Project	IEEE 802.16 Broadband Wireless Access Working Group < http://ieee802.org/16 >	
Title	OFDMA-based Ranging within Relay Zone	
Date Submitted	2007-03-05	
Source(s)	Kanchei (Ken) Loa, Yi-Hsueh Tsai, Yung-Ting Lee, Shiann-Tsong Sheu, Frank C.D. Tsai, Youn-Tai Lee, Hua-Chiang Yin, Heng-Iang Hsu, Chih-Chiang Hsieh Institute for Information Industry 8F., No. 218, Sec. 2, Dunhua S. Rd., Taipei City, Taiwan.	Voice: +886-2-2739-9616 Fax: +886-2-2378-2328 loa@nmi.iii.org.tw
Re:	IEEE 802.16j-07/007r2: "Call for Technical Comments and Contributions regarding IEEE Project 802.16j"	
Abstract	This document is to define operation of OFDMA-based ranging within relay zone in IEEE 802.16j-06/026r2.	
Purpose	Adopt the text proposal in this document	
Notice	This document has been prepared to assist IEEE 802.16. It is offered as a basis for discussion and is not binding on the contributing individual(s) or organization(s). The material in this document is subject to change in form and content after further study. The contributor(s) reserve(s) the right to add, amend or withdraw material contained herein.

OFDMA-based Ranging within Relay Zone

Figure 1 Proposed Ranging Code Sets within Relay Zone

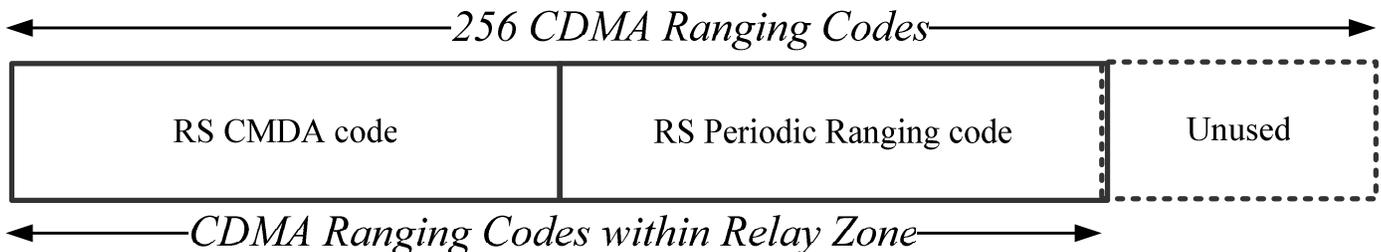
Two new ranging code sets, “periodic ranging code within relay zone” and “RS CDMA code within relay zone”, are proposed for relay station operation. The allocation of the two ranging code sets is determined by MR-BS.

The number of available codes is 256, numbered 0..255. Each BS uses a subgroup of these codes, where the subgroup is defined by a number S_r , $0 \leq S_r \leq 255$. The group of codes will be between S and $((S_r + N_r + M_r) \bmod 256)$.

- The next N_r codes produced are for RS CDMA code within relay zone. Clock the PRBS generator $144 \times (S_r \bmod 256)$ times to $144 \times ((N_r + S_r) \bmod 256) - 1$ times.
- The next M_r codes produced are for RS periodic-ranging within relay zone. Clock the PRBS generator $144 \times ((N_r + S_r) \bmod 256)$ times to $144 \times ((N_r + M_r + S_r) \bmod 256) - 1$ times.
